Addendum #2 – Issued December 3, 2012

Regarding Bids for **Engineer Road Maintenance Building – MEP, Fire Protection, General Trades & Fueling System (ITB 12-032P)** for Lucas County Engineer Road Maintenance, bid opening scheduled for December 6, 2012 at 2:00 P.M. (local time).

ADDENDUM NO. 02

Lucas County Road Maintenance Building
Bid Package #12-032P – Plumbing, Mechanical, Electrical, Fire Protection,
General Trades and Fueling Station Packages
Dated 12/3/2012

1
SKA-05

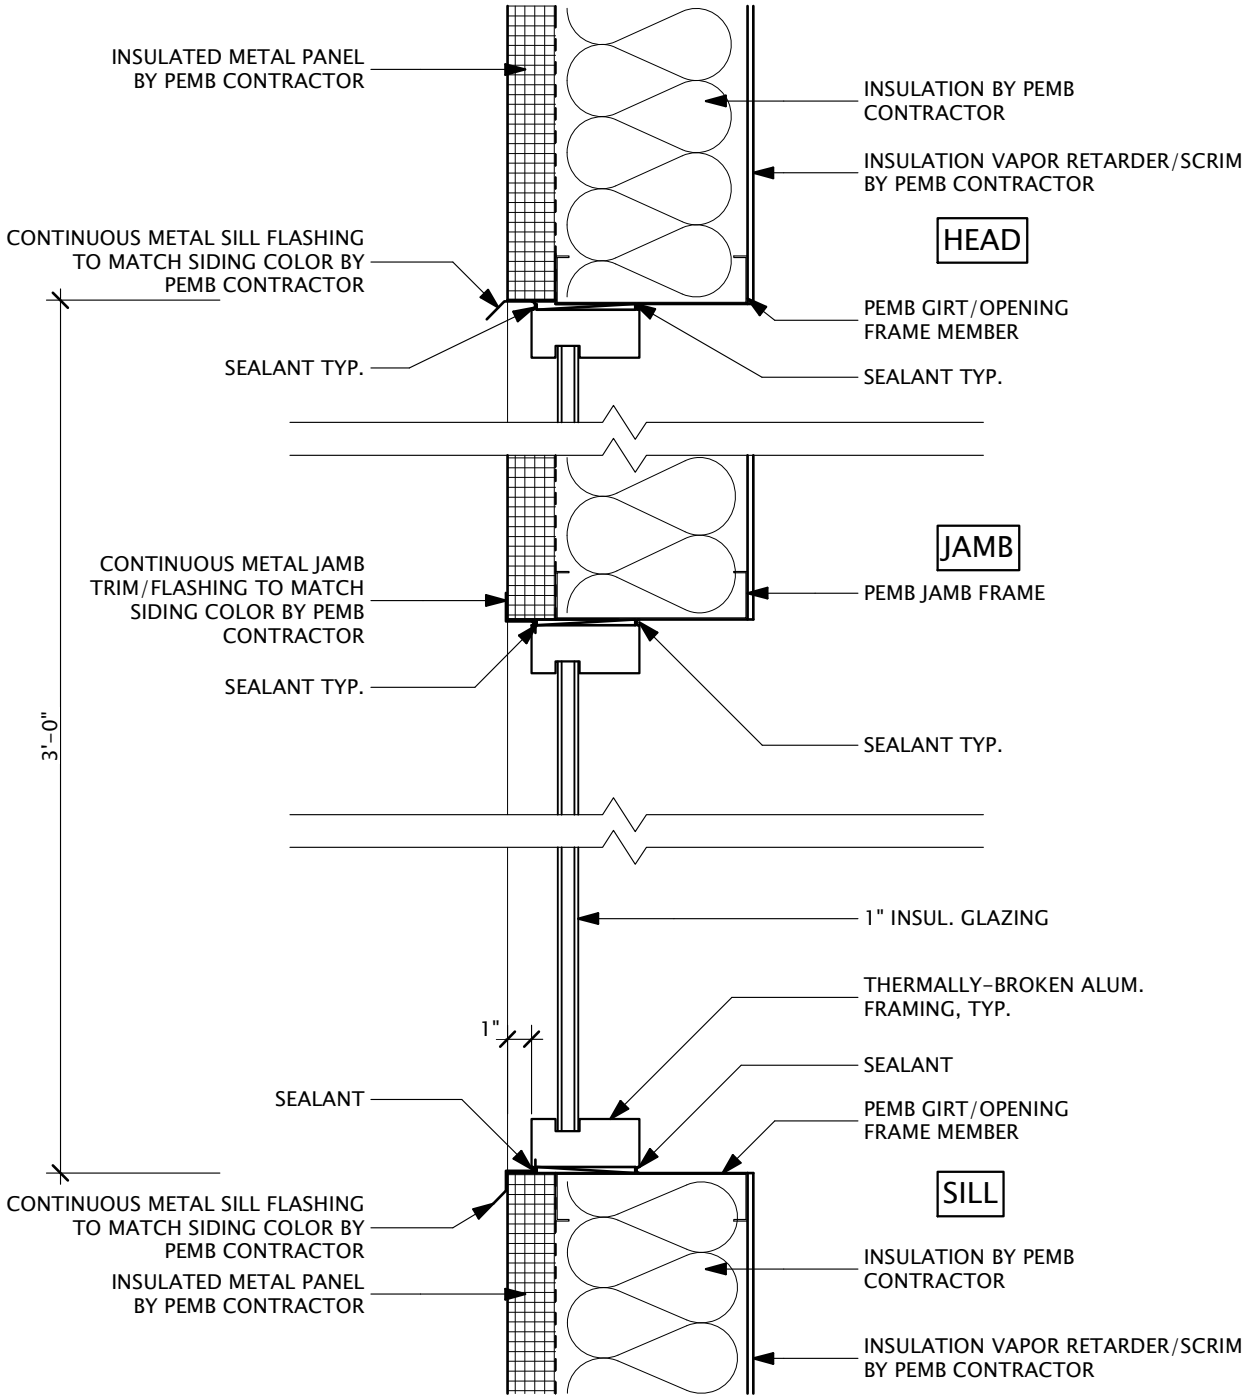
f) (General Trades) Question – Scope 6.6.9 room high bay windows. Need size and Detail. Nothing on drawings. Only shown on south elevation drawing A3.01.

Answer: High Bay Windows are dimensioned on sheet A1.03 MEZZANINE PLAN, although the window openings are not currently visible and sheet A3.01 EXTERIOR ELEVATIONS indicates the head height. The window units are 36-inches in height. The PEMB Manufacturer and Contractor will provide framing for the sill and head support with appropriate shim space as coordinated with General Trades Contractor. Windows are set back from face of siding 1-inch and metal closure trim to match siding is to be provided by PEMB. Windows are aluminum and requirements specified in 084113 ALUMINUM-FRAMED PUNCHED WINDOW OPENINGS and 088000 GLAZING. Refer to Sketch SKA-05.

1 SKA-06 SHOWER BASE DETAIL

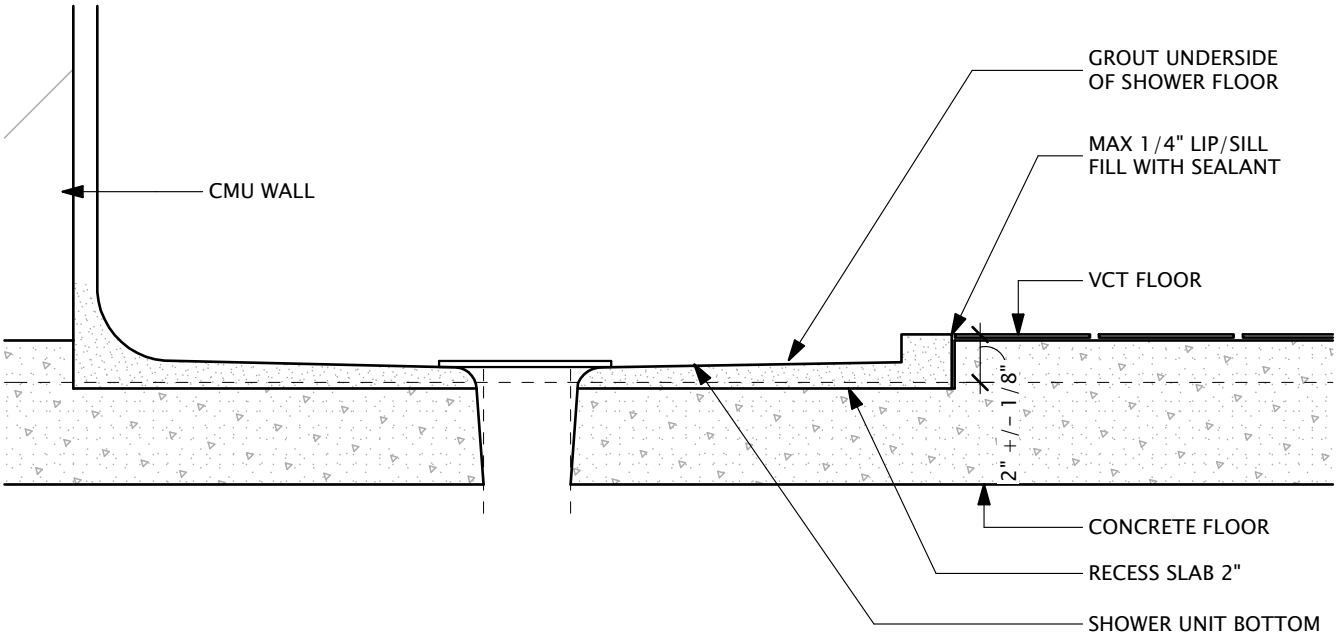
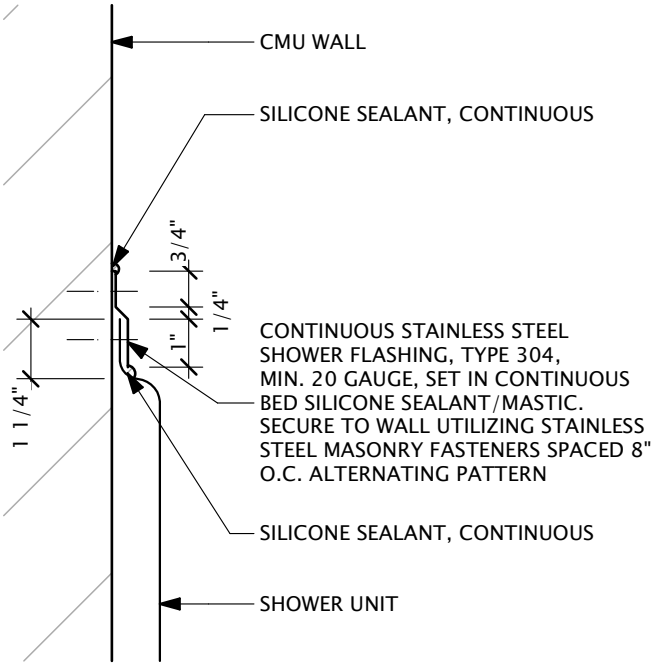
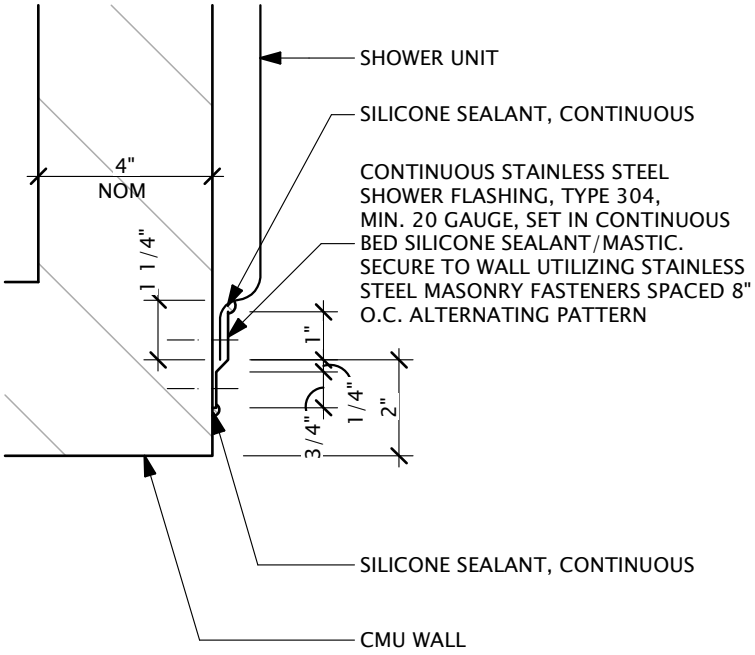
k) (General Trades) Question – Shower Compartment – Drawing A1.11 Detail D6 needs Specification.

Answer: Shower unit specification is under the Plumbing Drawings. See sheet P0.02. Refer to Sketch SKA-06 issued with this Addendum for additional details for shower unit.

AUTOMATIC SPRINKLER SYSTEM RISER DETAIL

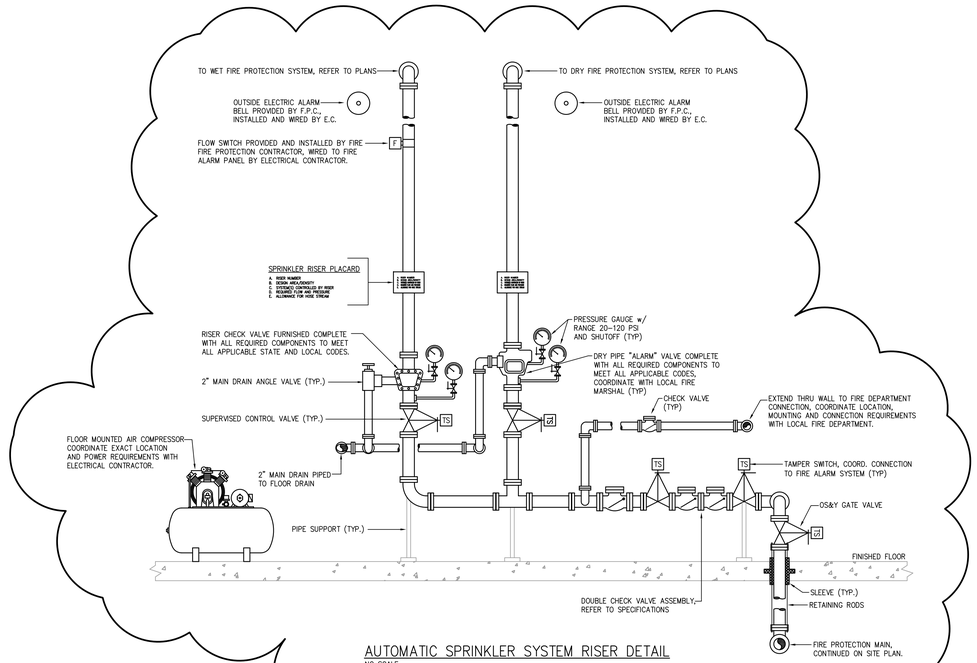
Drawing FP0.01 Fire Protection Schedule, Legend & Details (drawing reissued):
Item #1 Revise Sprinkler Riser Detail, add dry riser and associated air compressor.
Item #2 Clarification: revise sprinkler head schedule, SP-3.
Item #3 Add water flow test information.
Item #4 Delete Automatic Air Valve and detail.

AIR COMPRESSOR PIPING DIAGRAM
NO SCALE

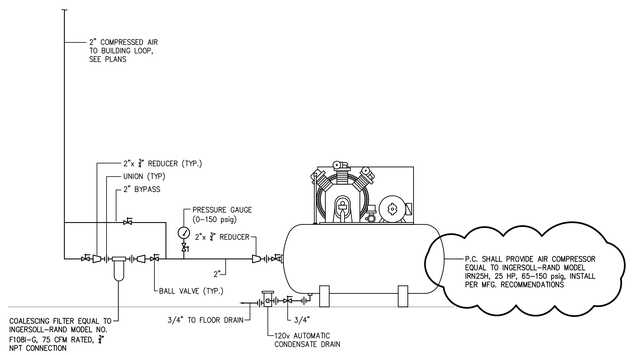
Drawing P0.03 Plumbing Details (drawing reissued):
Item #1 Add Wash Bay piping detail and schematic.
Item #2 Clarification: Air compressor equal to Ingersoll-Rand model IRN25H shall be provided by plumbing contractor.

OVERALL FIRST FLOOR PLAN – PLUMBING – ABOVEGROUND

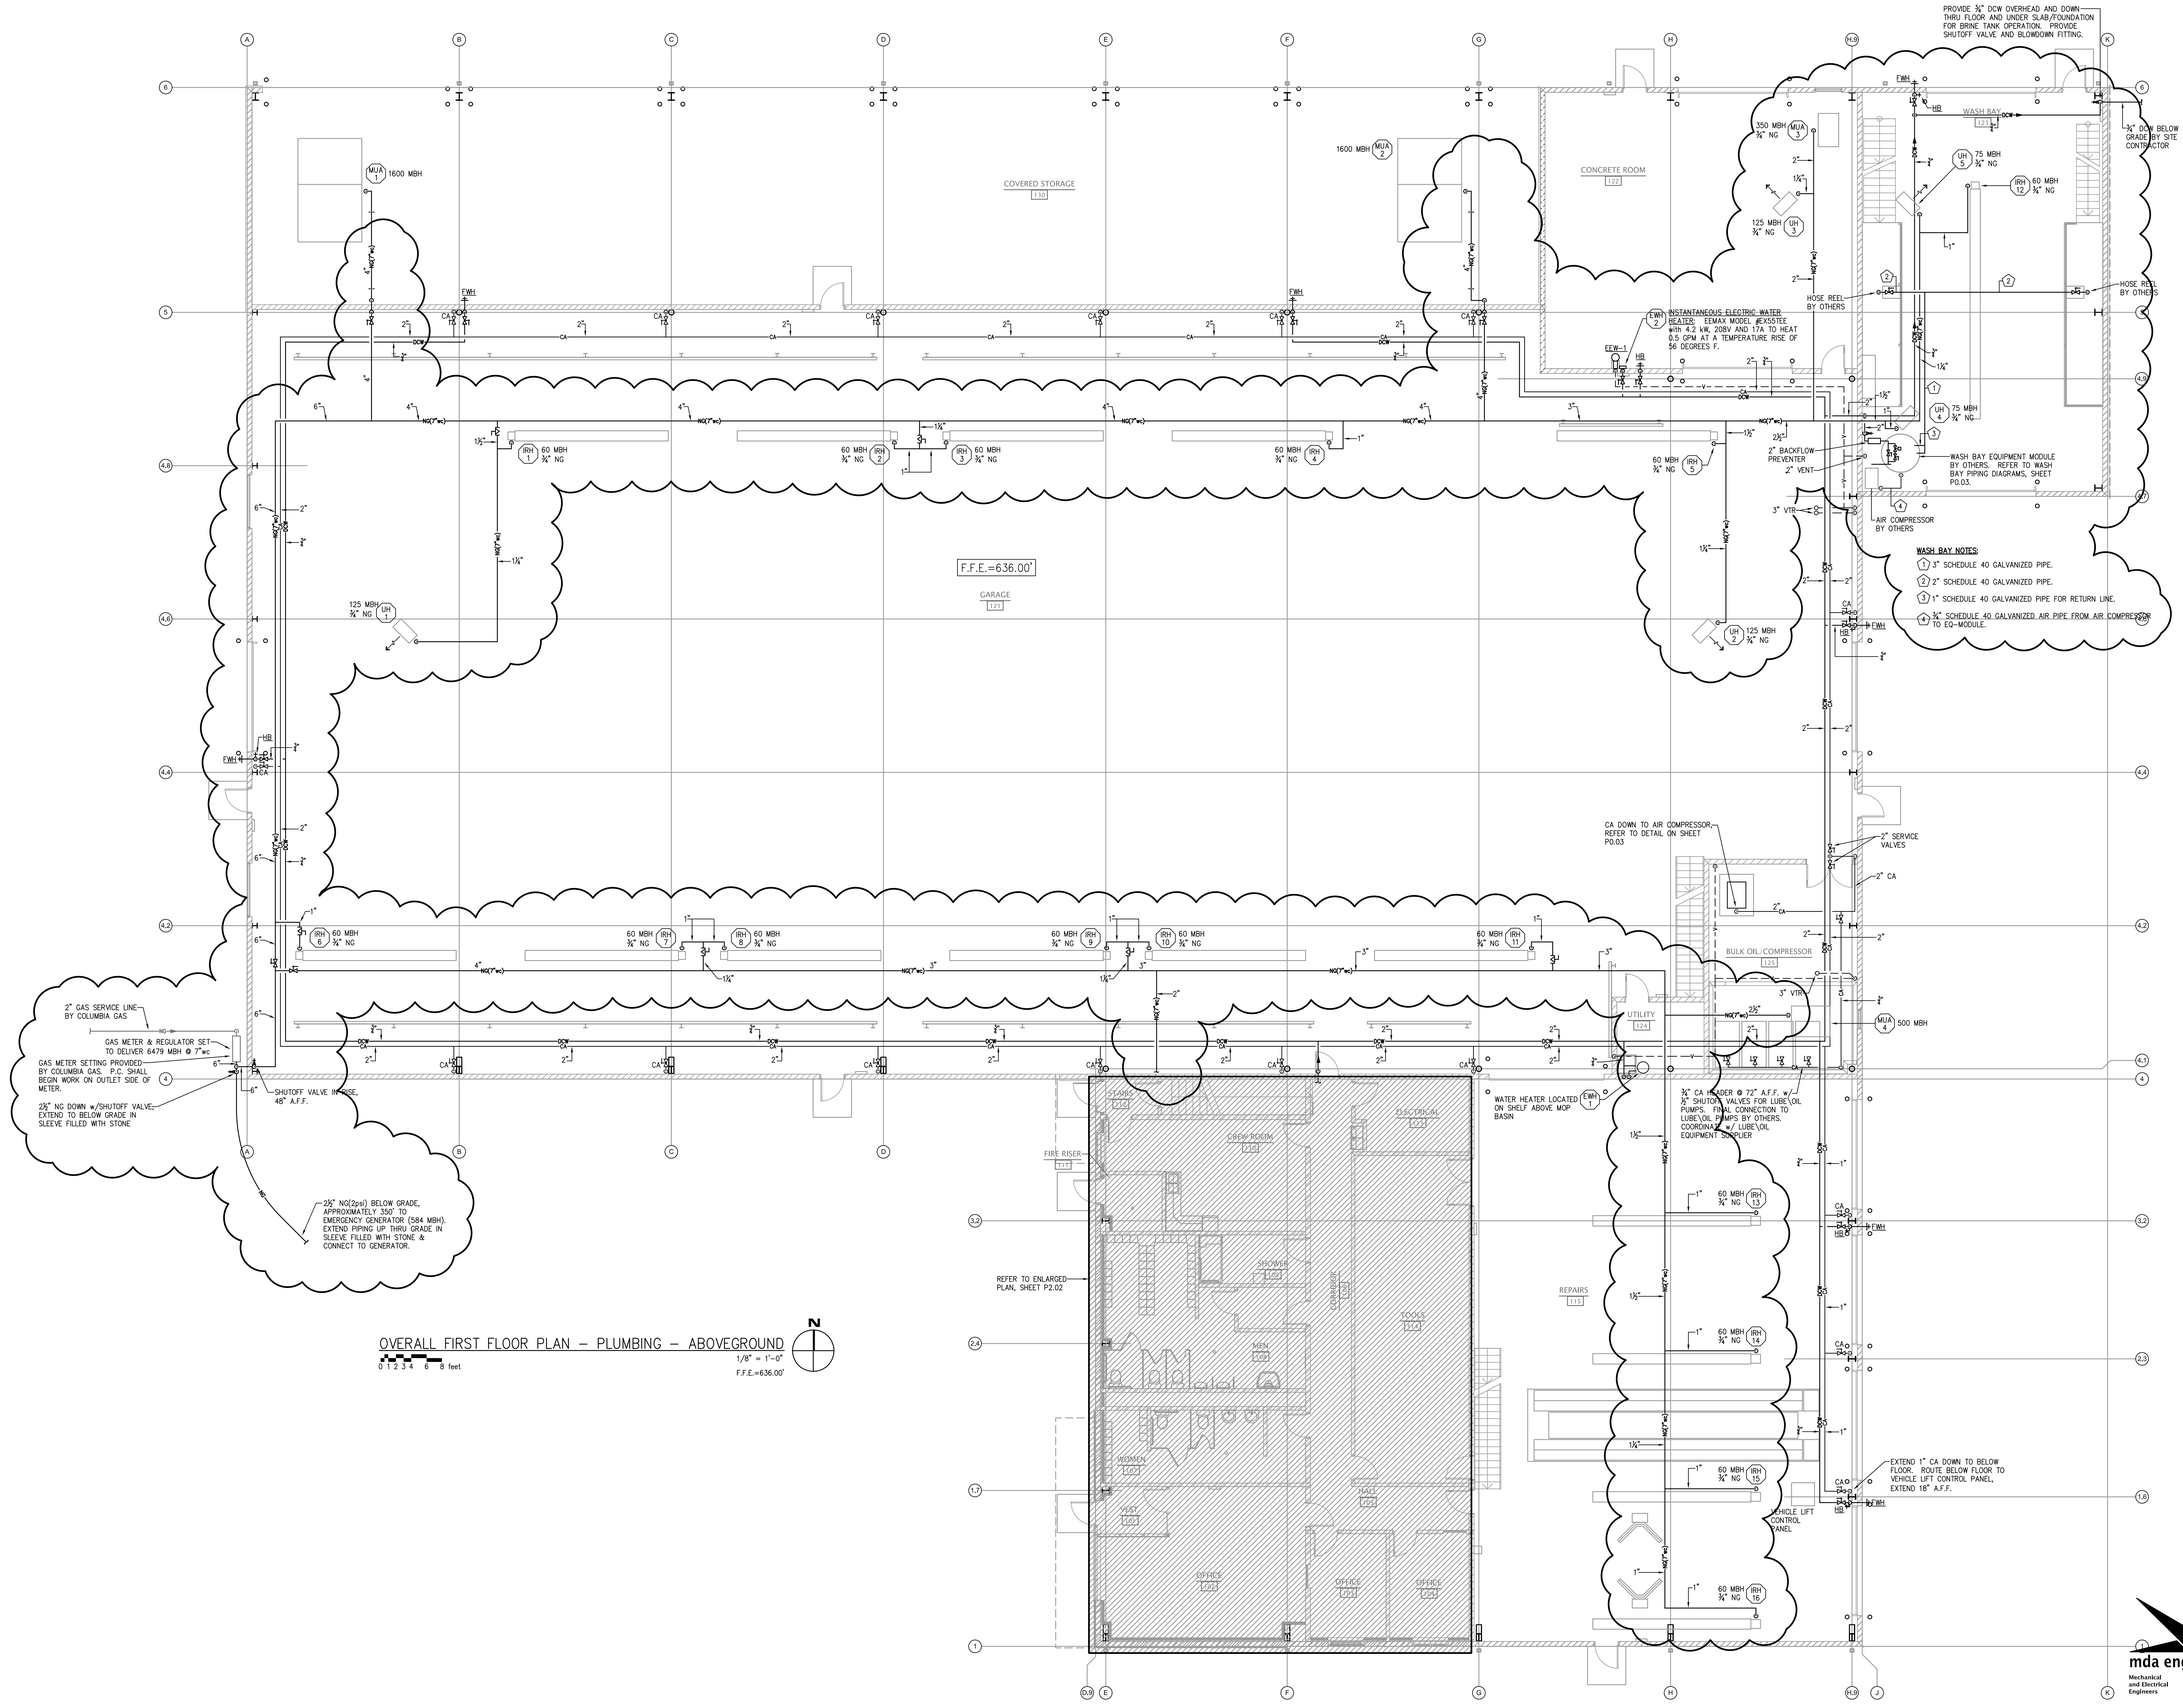
Drawing P1.02 First Floor Plan – Plumbing – Aboveground (drawing reissued):
Item #1 Revise gas piping sizes. Gas piping sized @ 7”wc, 2 psi not available.
Item #2 Add Wash Bay aboveground piping and notes.
